Access Compliance Report Public Rights-of-Way (Island Curb Cuts)

Main Street:SENDERO_WAY		Cross Street:SENDERO_WAY		Location:	NE
ADA ID: CCRK211117153011	Curb Cut Type:MedianRefuge2	Initial Pass/Fail: Pass	Overall Compliance: No	Severity Score:	15
Codes/Mitigation Info/Possible Solution			Field Measurements/Component Compliance

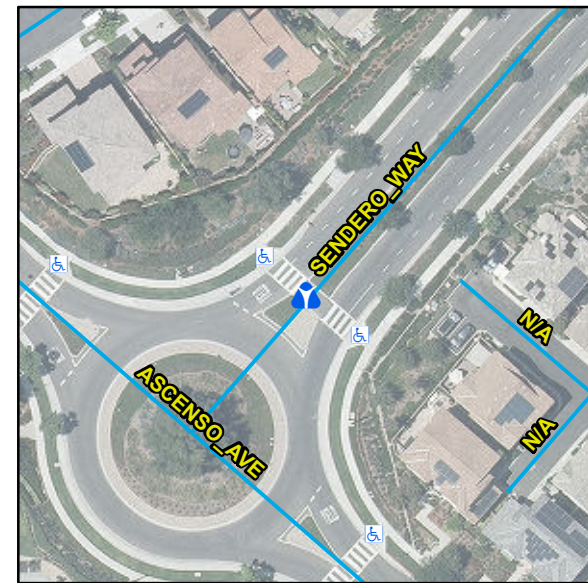
Install Detectable Warning System. Remove & Replace Gutter.
